Noyac Bay

REVISED

SUITE 211
ORIGINAL LAYOUT
INVENTORY SUITE

*** SUITE 211 * (INVENTORY SUITE)**
NEW PLAN
-REMOVED DEN
-REVISED KITCHEN
*REVISED LAUNDRY DOOR SWING &
ENSUITE WALL AS PER THIS BROCHURE

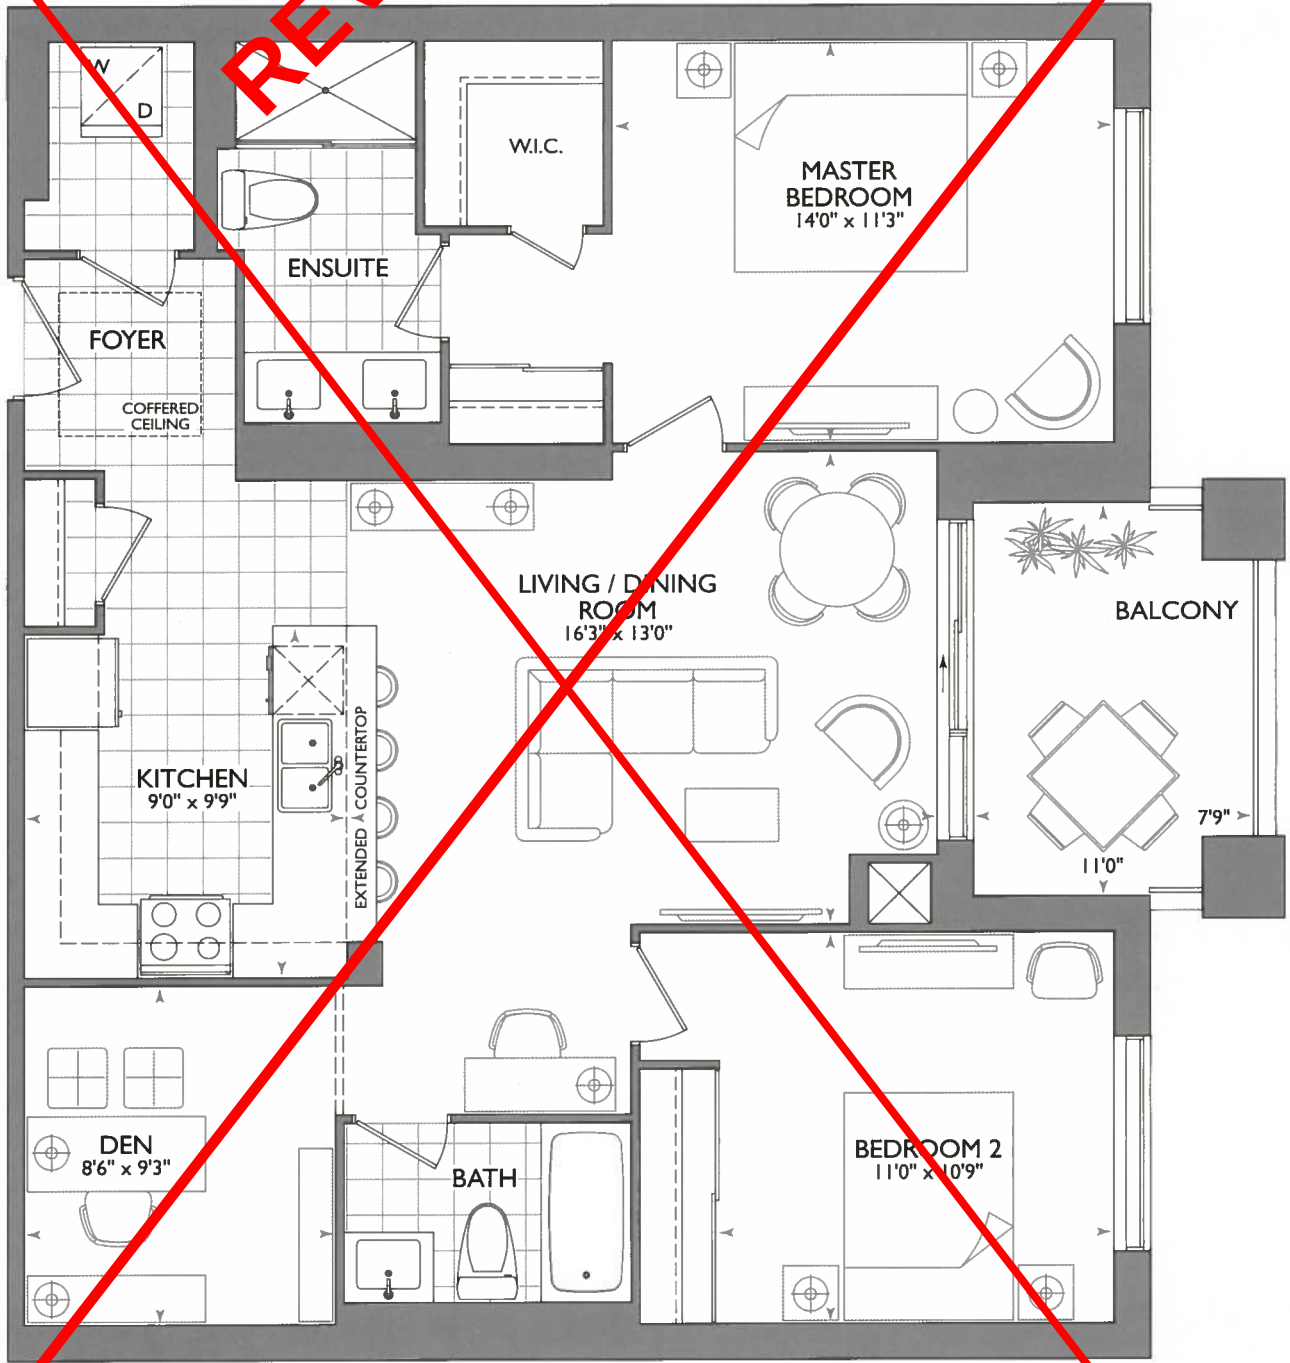
1,121 SQ FT *plus 76 sq. ft. of balcony area*

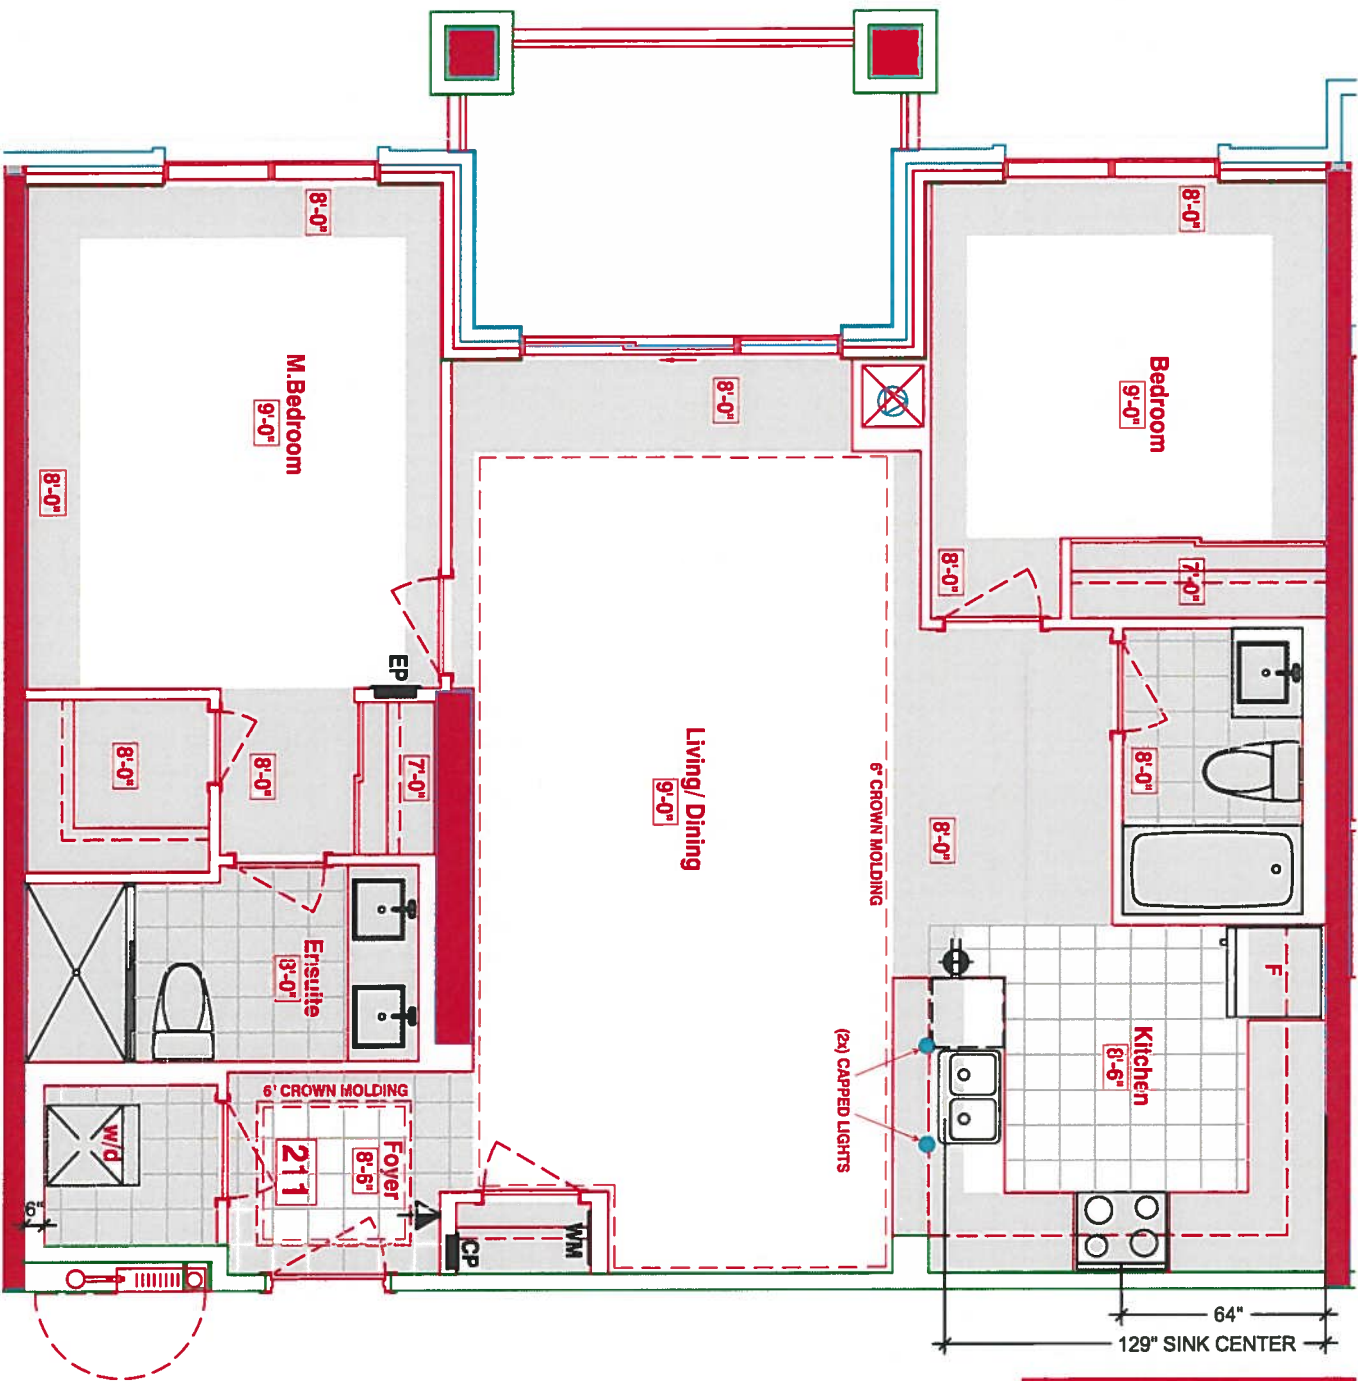
*** KITCHEN ***
CHOICE OF STD. KITCHEN LAYOUT WITH
STD. APPLANCE PACKAGE
OR
CAN UPGRADE AT DECOR CENTER
-(x2) CAPPED PENDANT
-(x1) PLUG PENINSULA
-(x) PUCK LIGHTS
*SEE ATTACHED UPG.
#1- KITCHEN LAYOUT WITH 1ST UPG.
APPLANCE PACKAGE
